**Subject:** 21/02265/FUL

Following the meeting of the Caldecote Parish Council 4<sup>th</sup> November, we discussed the above application, our comments are attached.

# Objection to 21/02265/FUL – Linden Phase 2 – 20 October 2021

## Flood Risks Directly From Appendix 4 Marked Onto Appendix 1 Plans

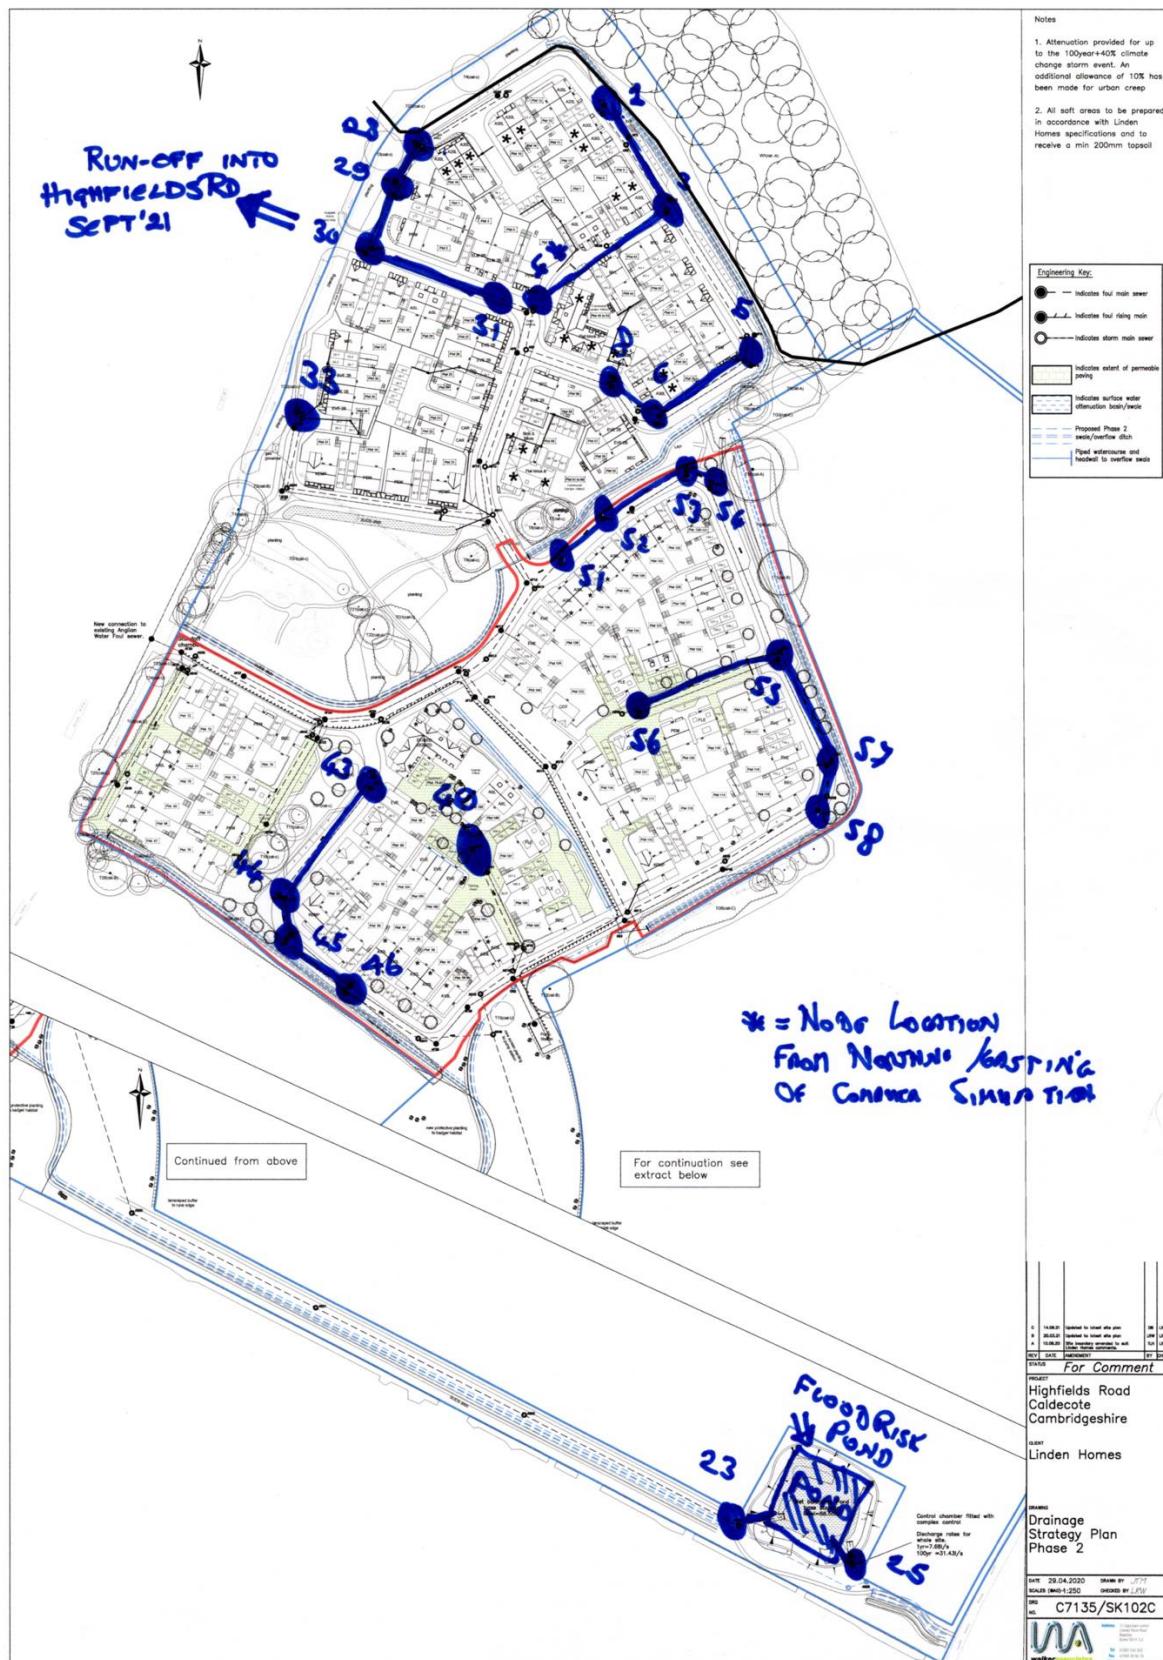
The nodes at risk are shown on the diagram at the end of this document, which shows a marked-up plan of the network drawn over Lindens own drainage plans. (As background the previously submitted phase 2 plan that contained previously notified errors only had 2 nodes with flood risk.)

With reference to the enclosed marked up plan there are a number of areas of very significant concern to the whole of the village:

- Nodes 28/29/30. Any flooding from nodes 28/29/30 (identified as at risk in the simulation) will run into Highfields Road in the exact location where houses on Highfields Road have been flooded and made uninhabitable.

- Nodes 43/44/45/46. With reference to the topographic site survey (Appendix 3) any runoff from this area will flow to the southwest towards the junction of Clare Drive and Highfields Road spilling off the road to the west around node 44.

- No allowance was made in the phase 1 only drainage design (as previously submitted to SCDC) for any anticipated future phase 2 generated flows.
  - The pipe (nodes 20/21/22/...25 in Appendix 4) from the site to the attenuation pond that drains the whole site was specified in the approved phase 1 only plans as a 600mm diameter pipe based on phase 1 flows alone.

- This makes the safe addition of the flows from the 74 houses of phase 2 unlikely using the common 600mm pipe to the attenuation pond.
- In the phase 2 design, the same 600mm pipe (nodes 20/21/22/...25 in Appendix 4 of the previous reference) is specified as carrying flows from phases 1 and 2 with the Linden documented flooding risk to the inflow and outflow to the attenuation pond.

We believe that any satisfactory resolution will require not only revised plans but significant enlargement (replacement) of pipework in the ground and enlargement of the attenuation pond that must be undertaken before phase 2 commences. Specifically:
